## Specialist Response Template – Fast-track Approvals Act 2024 – Substantive Application

### Technical Specialist Memo - Stormwater

Fast-Track project name: Drury Quarry Expansion – Sutton Block

Fast-Track application number: FTAA-2503-1037 (EPA reference) + BUN60449474 (Auckland Council reference)

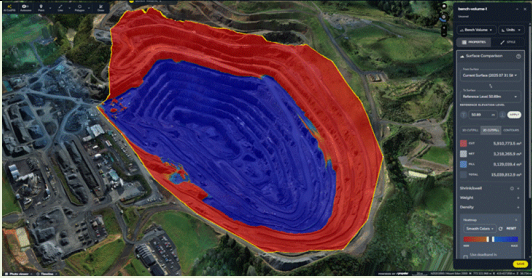
| 71 | <p><b>SIZING OF THE SUTTON BLOCK PIT SUMP</b></p> <p>The application does not include any technical explanation or hydraulic calculations to demonstrate how the Sutton Block pit sump has been sized in relation to predicted inflows from rainfall, stormwater runoff, groundwater dewatering, or water reuse demand.</p> <p>Why is this Information Essential? - Without a technical basis for the pit sump sizing, it is not possible to assess whether it has adequate capacity to capture and treat water during storm events or to prevent overtopping or uncontrolled discharges, particularly as the pit deepens over time. This limits confidence in the overall effectiveness of the water management system and the mitigation of downstream effects.</p> | <p>All dirty water from the Sutton Block is proposed to be pumped to the Drury Quarry Pit. As set out in Section 6.2.2 of the AEE and Section 2.6 of the ESCR, the existing Drury Quarry water is pumped from the pit via a turbidity-controlled pump. If the turbidity of the water being pumped exceeds the set limit, the system automatically shuts off, retaining the water within the pit until turbidity levels drop below the threshold and pumping can safely resume. Should water need to be removed from the pit while exceeding the turbidity limit, it will be pumped to the Drury Water Treatment System (lamella) for treatment before being discharged off site via the clean water pond.</p> <p>The Drury Quarry pit currently has approximately 9.1 million cubic metres of storage volume (Figure 1 below), which is more than sufficient to retain both stormwater and ground water inflow. The progressive nature of quarrying operations also means that the storage volume of the pit will continue to increase as the quarrying operation progresses. Based on the above, storage volume within the pit will not be an issue for all inflows and therefore additional calculations are not deemed to be necessary.</p> | <p>Addressed. It is agreed that more than sufficient volume available within the Drury Quarry Pit to detain runoff before discharge to onsite treatment systems in times of high rainfall.</p> <p>It is recommended that the Quarry Management Plan is update to include processes or procedures for pumping to the Drury Quarry Pit , specifically in times of high rainfall that may exceed pump capacity, and during establishment phases of the Sutton Block Pit, where there may not yet be sufficient volume in the Sutton Block Pit to detain water before it is pumped to the Drury Quarry Pit.</p> | -                                                                                                                                                                                                                                                                                                                                                                  | - |

| 72 | <p><b>CAPACITY OF THE EXISTING DRURY QUARRY WATER TREATMENT SYSTEM</b></p> <p>While the AEE outlines that the existing Drury Quarry water treatment system (including the lamella and clean water pond) has ‘significant extra capacity’, it does not quantify this capacity or confirm how much of this capacity will be allocated to or consumed by the Sutton Block operations.</p> <p>Why is this Information Essential? - Without quantification it is unclear whether the Drury Water Management System can accommodate peak flows from both the existing and proposed quarry pits operating simultaneously (particularly during the crossover period), or during high rainfall periods. This introduces uncertainty in the ability of the existing Water Management System to provide mitigation simultaneously from both pits during any cross over period to avoid adverse effects on receiving waters.</p> | <p>The capacity of the existing Drury Quarry system is irrelevant as water within the pit is impounded and held as long as needed. Any discharges from the pit are controlled. The lamella is set at a pre-determined rate of discharge that never changes as the site team control the amount of water entering the lamella. All other water is held in the pit and controlled via turbidity controlled pumps.</p>                                             | <p>Addressed. It is agreed that more than sufficient volume available within the Drury Quarry Pit to detain runoff before discharge to onsite treatment systems</p> | - | - |
